IN THE MATTER of applications by Waka Kotahi
NZ Transport Agency to Manawatu Whanganui
Regional Council for resource consents
associated with the construction and operation of
Te Ahu a Turanga: Manawatū Tararua Highway.

**SECTION 87F REPORT OF JOHN ROBERT HUDSON - NATURAL CHARACTER
AND LANDSCAPE CHARACTER**

Figure I.3: Calibration Diagram

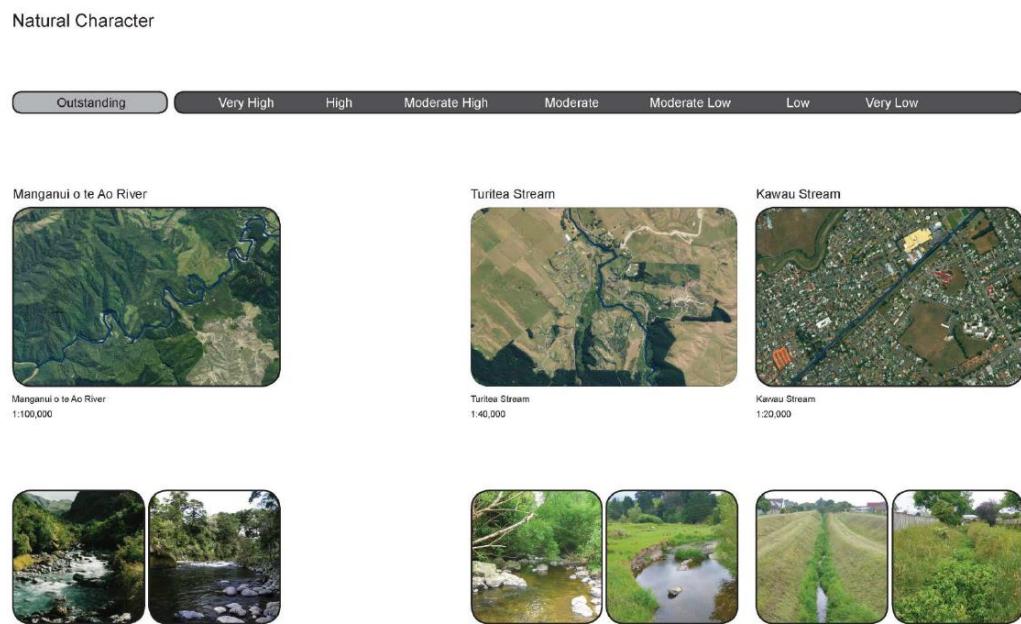
27. I acknowledge that the Applicant has relied on a calibration process, as illustrated in the Calibration Diagram provided in Technical Assessment I.¹⁹ The absence of any calibration was a shortcoming identified by experts for the territorial authorities at the NoR hearing, and it is positive that this work has been done. However, the Calibration

Diagram only provides examples of rivers and streams with existing natural character ratings of Very High/Outstanding, Moderate, Moderate/Low and Low/Very Low. There are no examples of High and Moderate-High rivers and streams (shown in Figure 1.3, below). As a result, the Calibration Diagram would have had limited value during the assessment process when determining the existing natural character rating of Catchment 6 and 7, which are rated as Moderate-High QEII East.²⁰ While the Section 92 Response²¹ states that it would not be useful to provide more examples in the Calibration Diagram at this time (post calibration), the overall findings for those catchments would have been more robust if calibrated against examples in the region.

28. Overall, while reasons for the change in existing ratings for Catchment 6 and 7 are not readily apparent in Technical Assessment I, and while noting the limitations with the Calibration Diagram, after discussions with Mr Brown and Mr Lambie and following review of their reports, I accept the ratings of natural character provided in the application.
